Landmarks Commission

Staff Report

Agenda Item: 4
Case # SI-2024-00410
Project # PR-2024-010134
May 8, 2024

Agent	RBA Architecture, PC
Applicant	Church Street Café, Inc.
Request	Certificate of Appropriateness - Addition to an Accessory Building
Legal Description	Lot A, Plat of Lots A & B, Lands of Coleman and Sanzari
Address/Location	2111 Church Street NW
Size	0.1599
Zoning	MX-T
Historic Location	Old Town Historic Protection Overlay Zone, (HPO-6).

CHURCH STREET GARAGE FLOOR PLANS

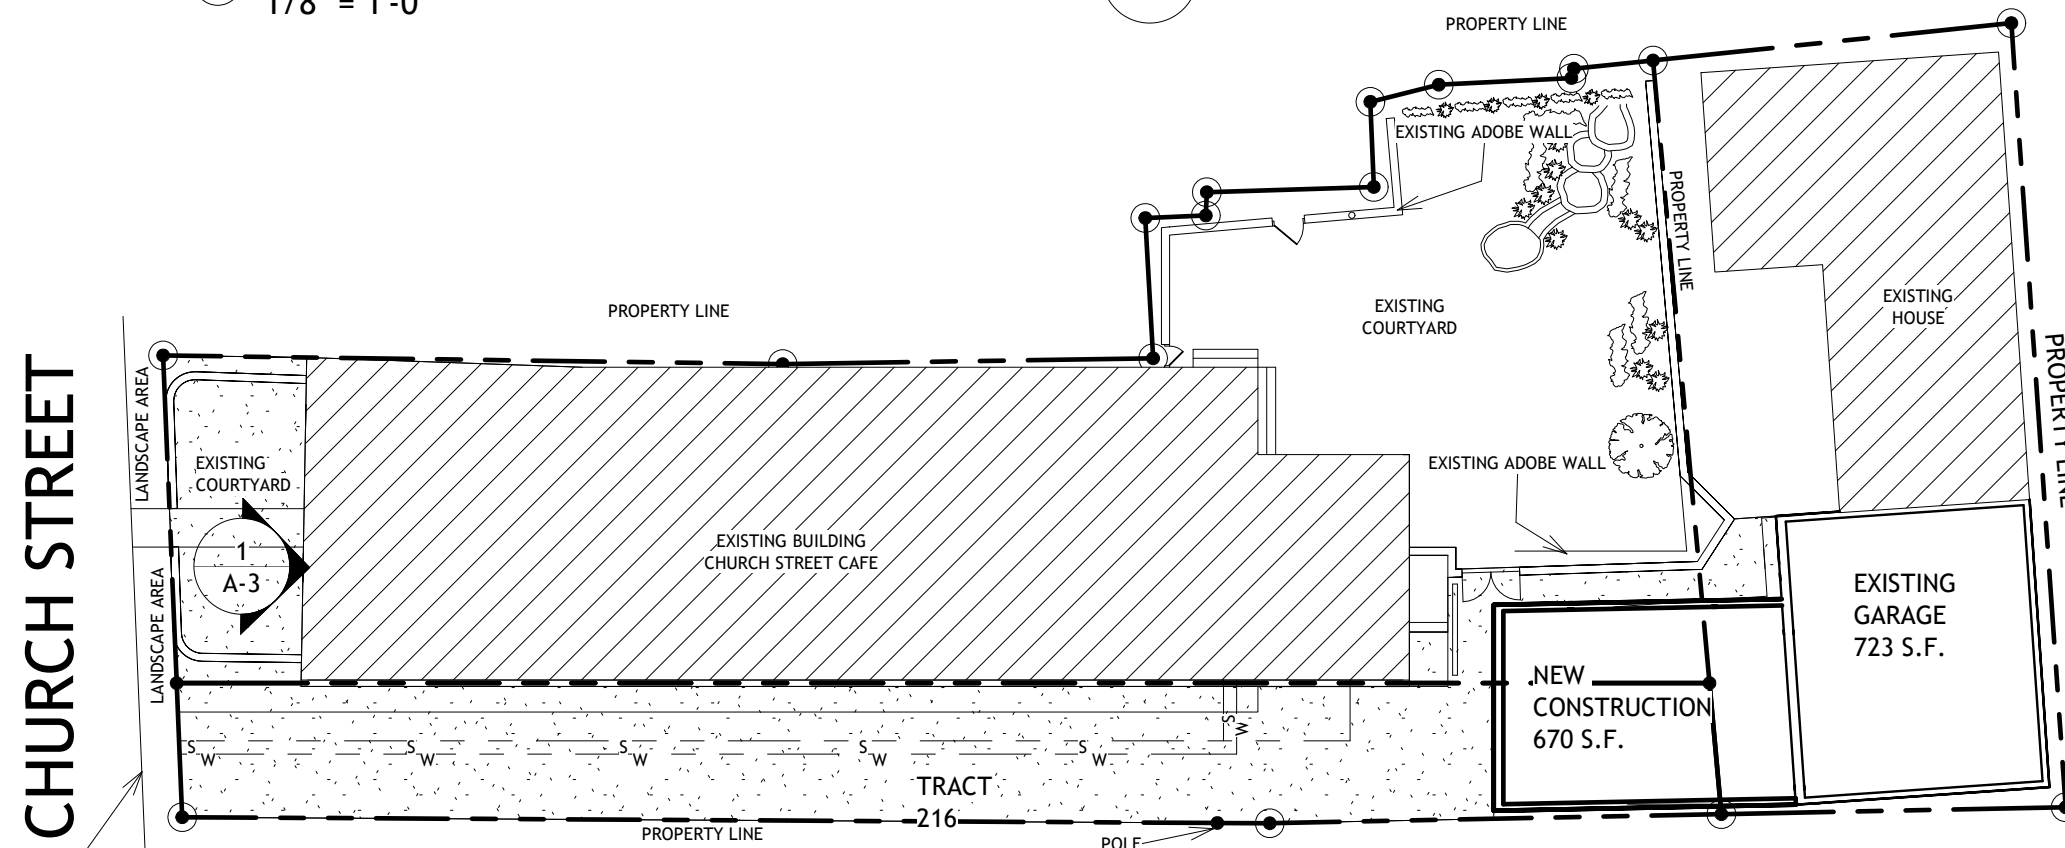
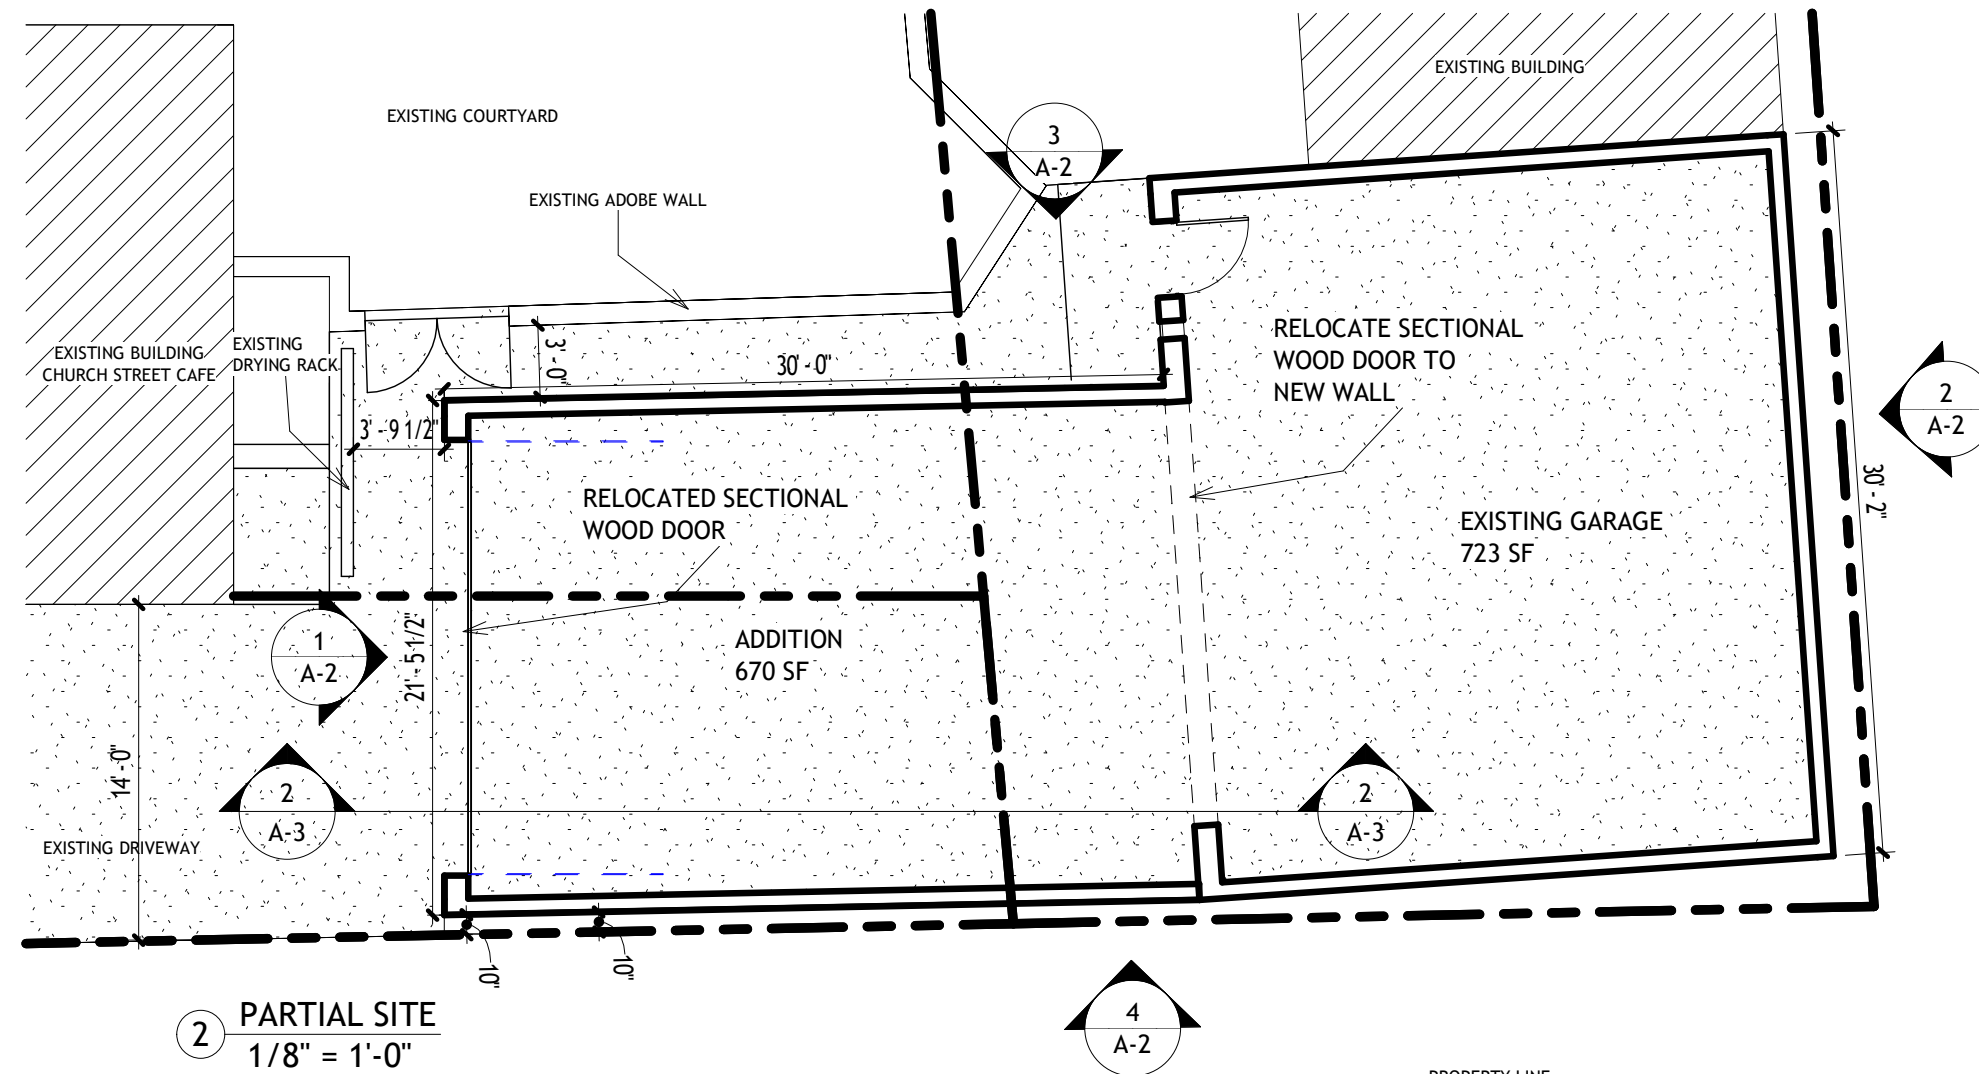
The garage is approximately 723 s.f. and, at this time, the applicant is requesting an addition of 670 s.f., well over the maximum 50% allowable. The scope of work will include:

The addition adheres to the minimum interior setback requirements for the MX-T zone, outlined in IDO Table 2-4-1: MX-T Zone District Dimensional Standards Summary.

CHURCH STREET GARAGE ELEVATION + SECTION

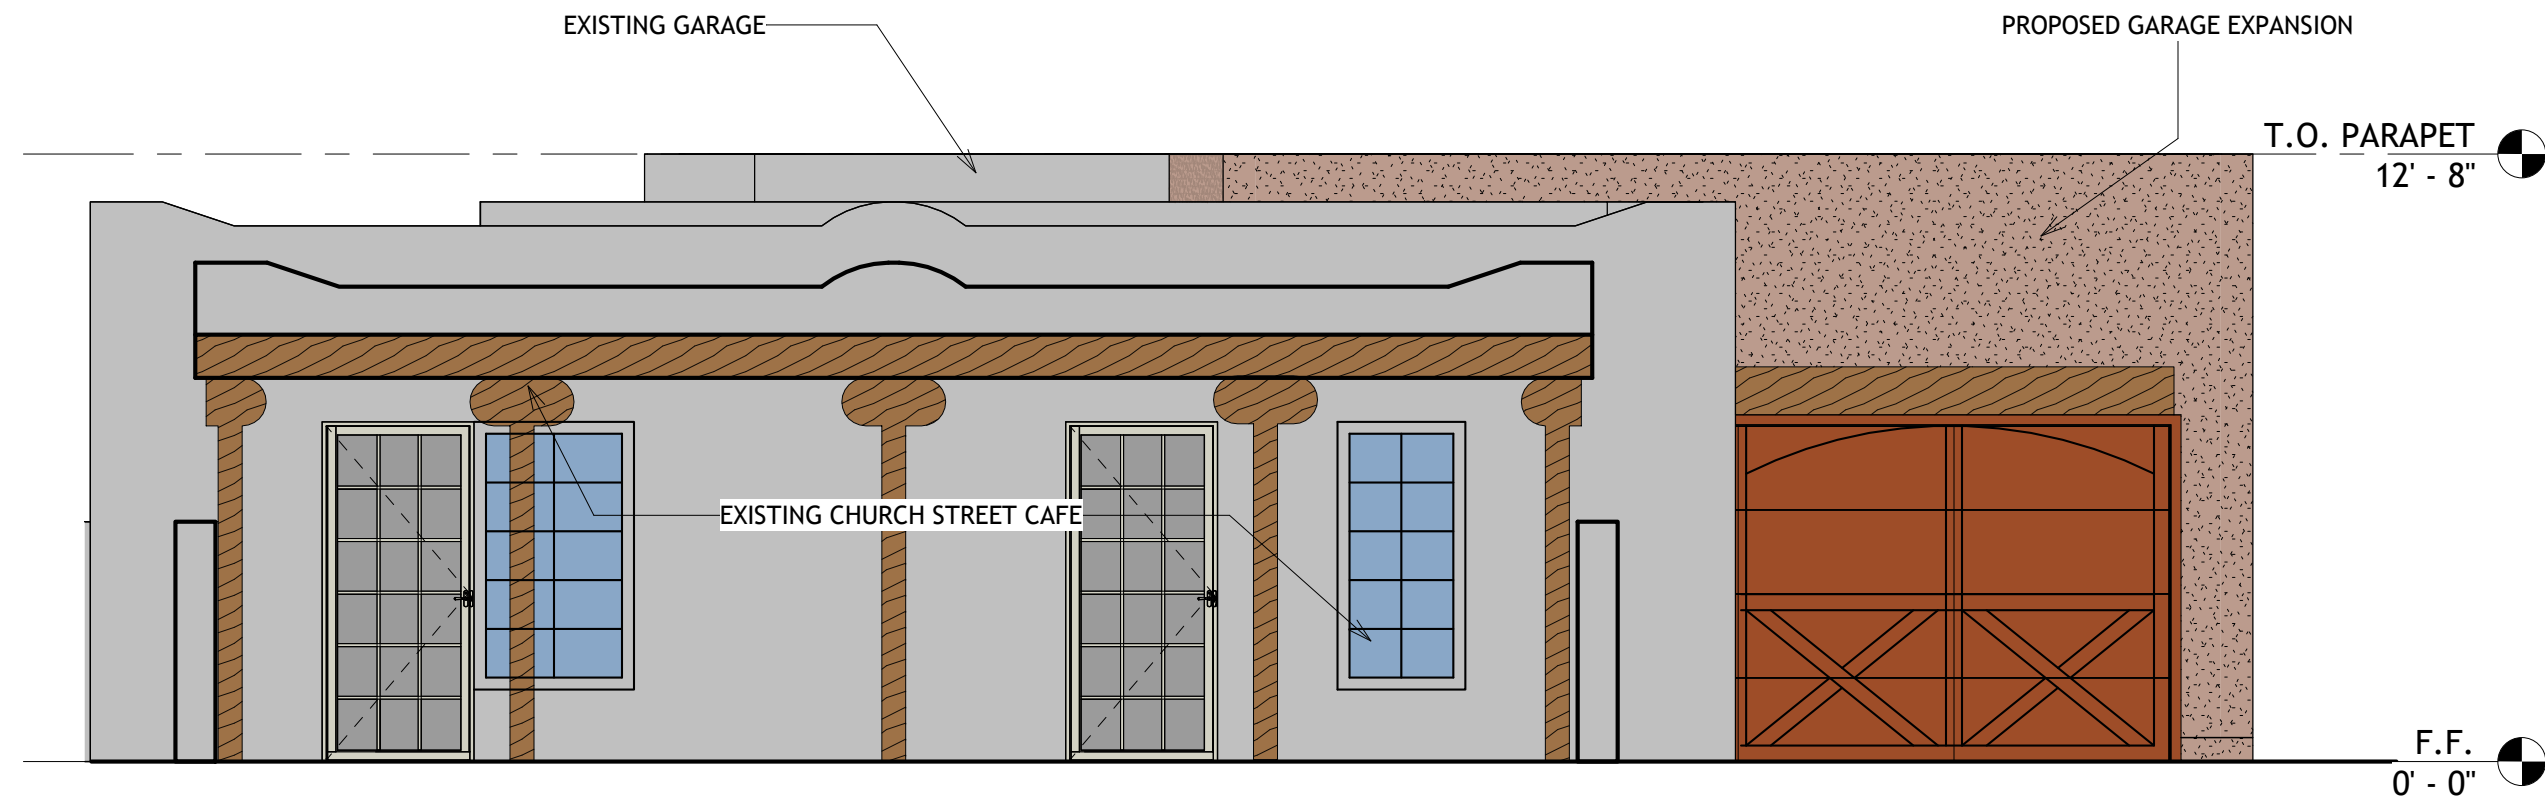
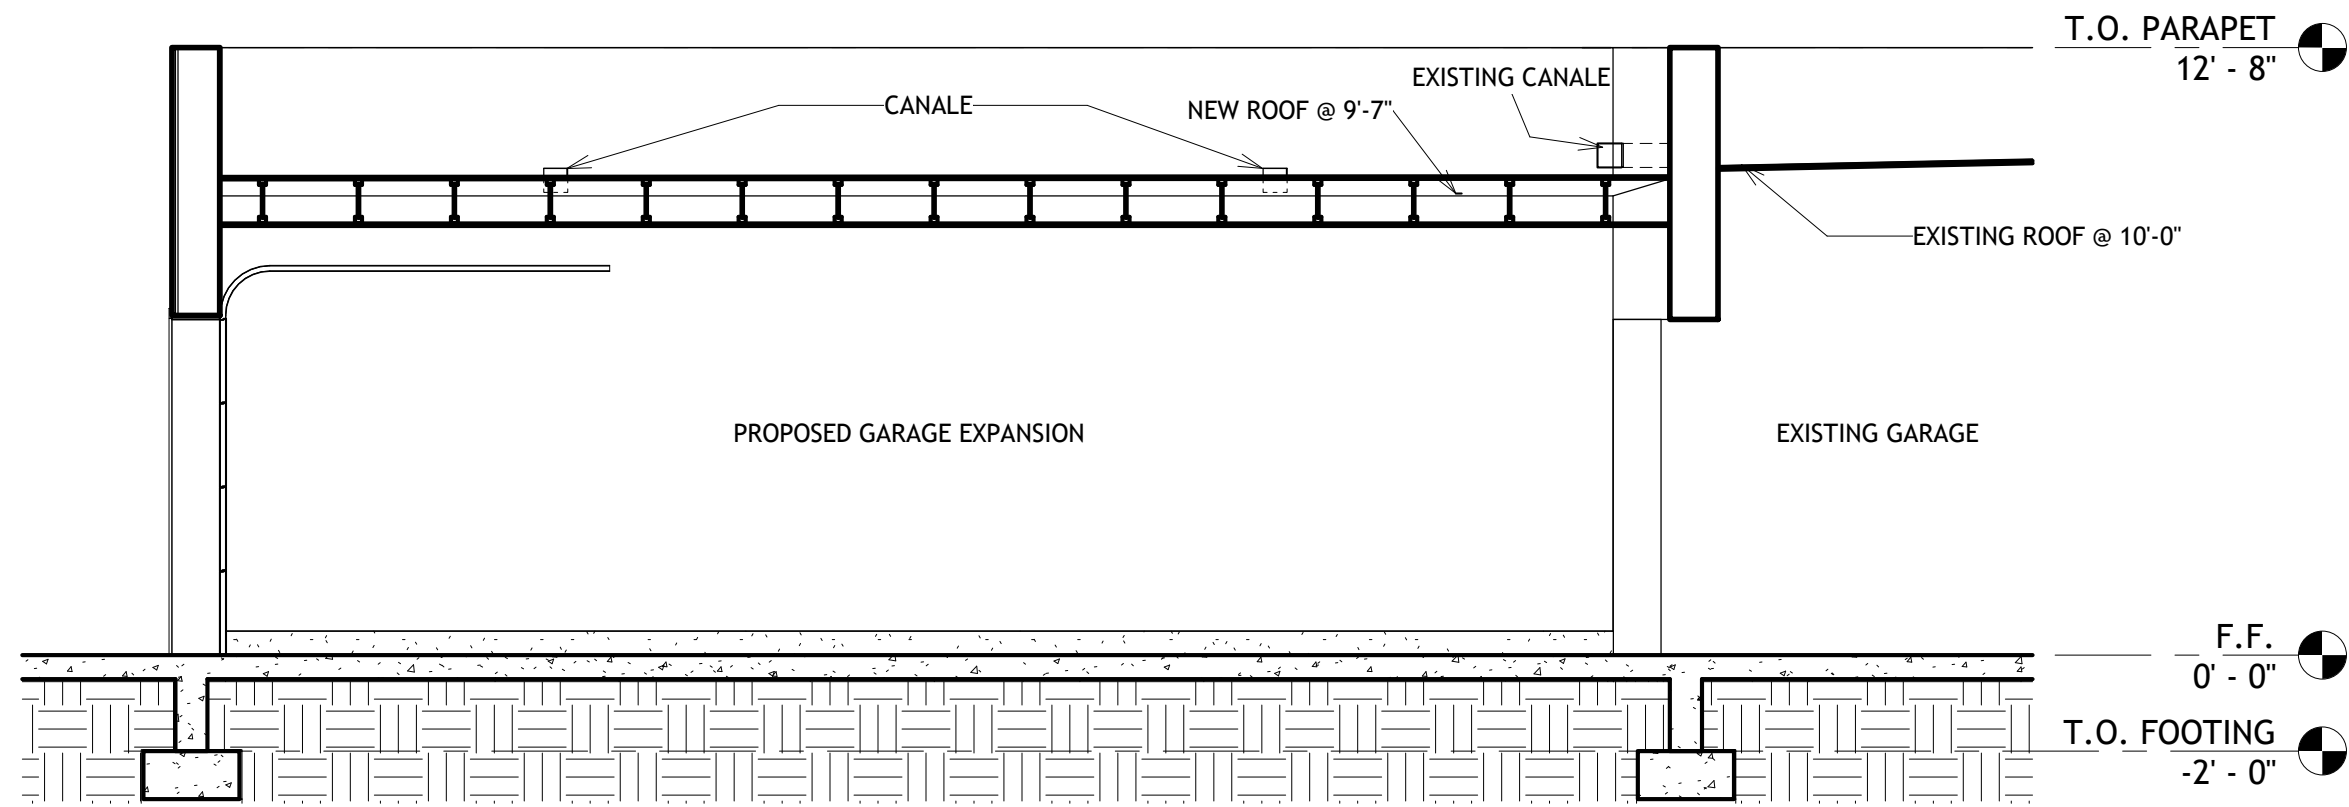
The addition will be at a height of 12'-8" to the top of the parapet, with the new roof at 9'-7", while the existing roof stands at 10'-0". The maximum allowable building height in the Old Town HPO-6 zone is 26 feet.
